# Product Change Notification

**Change Notification #: 115413 - 00**

**Change Title: Intel® Dual Band Wireless-AC 8260 SKUs:  
8260.NGWMG; 8260.NGWMG.K;  
8260.NGWMG.NV; 8260.NGWMG.NVL;  
8260.NGWMG.NVS; 8260.NGWMG.S;  
8260.NGWHLG.NV,  
PCN 115413-00, Label,  
Label Change**

**Date of Publication: April 10, 2017**

Example Labels:

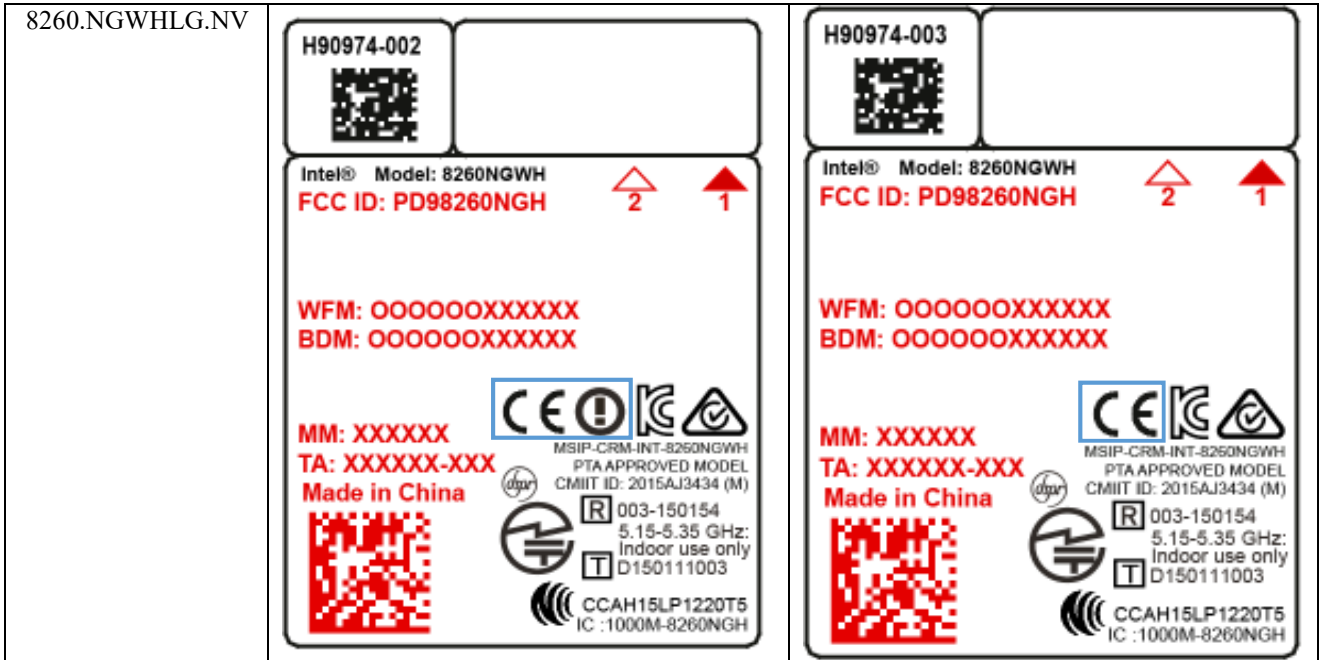
1. The current CE ! Mark on the module label will be modified to remove the Alert Symbol (!) following the CE mark.
2. We will be adding 2 graphics to the outer packaging to be visible by EU customs.
  - a. A new CE graphic:
  - b. The Intel Corporate address

- Revision number changing on the below SKU's.

SKU	Before	After
8260.NGWMG	0D	0E
8260.NGWMG.K	0D	0E
8260.NGWMG.NV	0D	0E
8260.NGWMG.NVS	0C	0D
8260.NGWMG.S	0C	0D
